Re: 251464-A  
Lot 3A Elbridge Farm

Pages or sheets covered by this seal: I76617465 thru I76617468

| 251464-A | B1GE  | PIGGYBACK ATTIC | 1   | 1   | Job Reference (optional) |           |

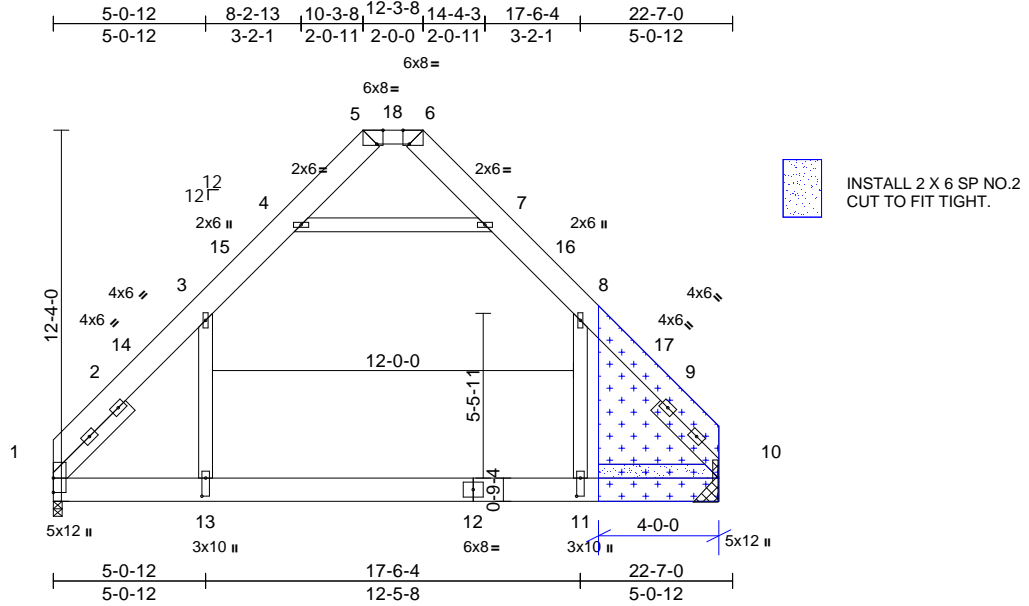
REPAIR: ADD 5 1/2"X9 1/4" NOTCH ON RIGHT END.

ATTACH 1/2" PLYWOOD OR OSB GUSSET (15/32" RATED SHEATHING 32/16 EXP 1) TO EACH FACE OF TRUSS WITH (0.131" X 2.5" MIN.) NAILS PER THE FOLLOWING NAIL SCHEDULE:  
2 X 3'S - 2 ROWS, 2 X 4'S - 3 ROWS, 2 X 6'S AND LARGER - 4 ROWS: SPACED @ 4" O.C.  
NAILS TO BE DRIVEN FROM BOTH FACES. STAGGER SPACING FROM FRONT TO BACK FACE FOR A NET 2" O.C. SPACING IN EACH COVERED TRUSS MEMBER. USE 2" MEMBER END DISTANCE.

| 251464-A                 | B2    | PIGGYBACK ATTIC | 1   | 1   | 176617466            |

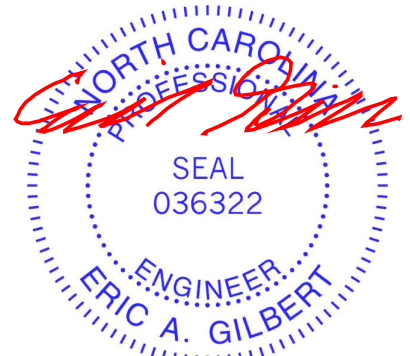
REPAIR: STUB RIGHT END 5 1/2"

ATTACH 1/2" PLYWOOD OR OSB GUSSET (15/32" RATED SHEATHING 32/16 EXP 1) TO EACH FACE OF TRUSS WITH (0.131" X 2.5" MIN.) NAILS PER THE FOLLOWING NAIL SCHEDULE:  
2 X 3'S - 2 ROWS, 2 X 4'S - 3 ROWS, 2 X 6'S AND LARGER - 4 ROWS: SPACED @ 4" O.C.  
NAILS TO BE DRIVEN FROM BOTH FACES. STAGGER SPACING FROM FRONT TO BACK FACE FOR A NET 2" O.C. SPACING IN EACH COVERED TRUSS MEMBER. USE 2" MEMBER END DISTANCE.

| 251464-A                 | B3    | PIGGYBACK ATTIC | 7   | 1   | 176617467            |

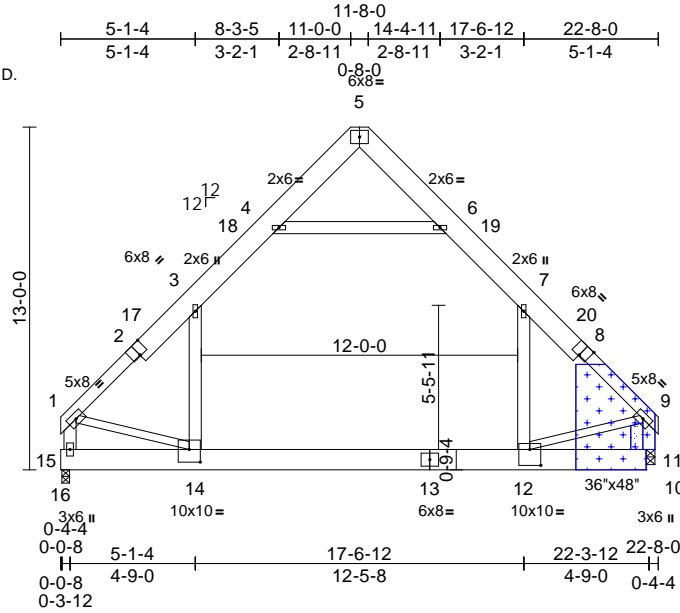
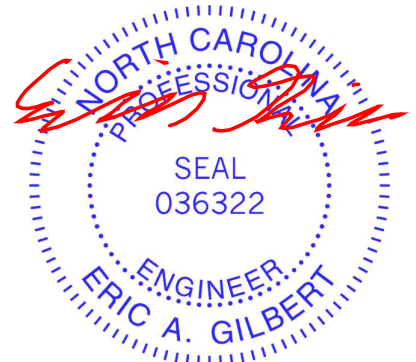
REPAIR: ADD 5 1/2"x9 1/4" NOTCH ON RIGHT END.

INSTALL 2 X 6 SP NO.2  
CUT TO FIT TIGHT.

ATTACH 1/2" PLYWOOD OR OSB GUSSET (15/32" RATED SHEATHING 32/16 EXP 1)  
TO EACH FACE OF TRUSS WITH (0.131" X 2.5" MIN.) NAILS PER THE FOLLOWING NAIL SCHEDULE:  
2 X 3'S - 2 ROWS, 2 X 4'S - 3 ROWS, 2 X 6'S AND LARGER - 4 ROWS: SPACED @ 4" O.C.  
NAILS TO BE DRIVEN FROM BOTH FACES. STAGGER SPACING FROM FRONT TO BACK FACE  
FOR A NET 2" O.C. SPACING IN EACH COVERED TRUSS MEMBER. USE 2" MEMBER END DISTANCE.

| 251464-A | B4    | PIGGYBACK ATTIC | 1   | 2   | Job Reference (optional) |

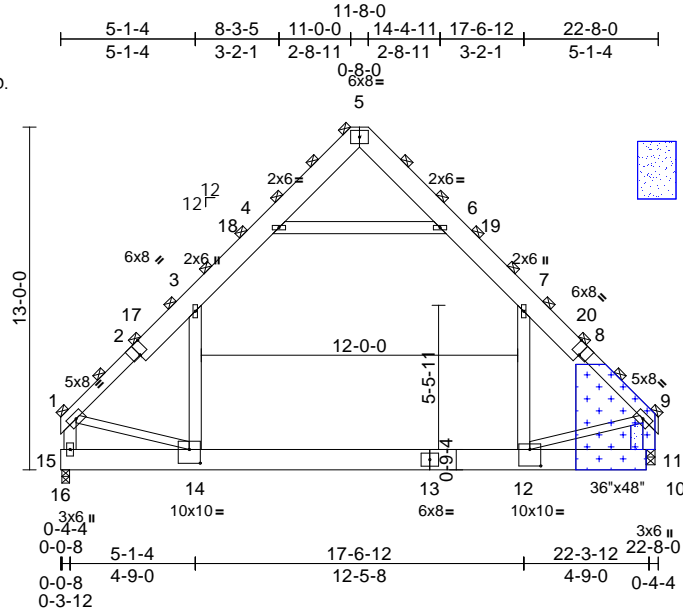
REPAIR: ADD 5 1/2"x9 1/4" NOTCH ON RIGHT END.

ATTACH < 2 LAYERS > 3/4" PLYWOOD OR OSB GUSSET (23/32" RATED SHEATHING 48/24 EXP 1) TO EACH FACE OF TRUSS WITH (0.131" X 3.0") NAILS PER THE FOLLOWING NAIL SCHEDULE: 2 X 3'S - 2 ROWS, 2 X 4'S - 3 ROWS, 2 X 6'S AND LARGER - 4 ROWS: SPACED @ 3" O.C. USE 2" MEMBER END DISTANCE. GLUE PLYWOOD LAYERS TOGETHER PRIOR TO ATTACHING TO TRUSS.
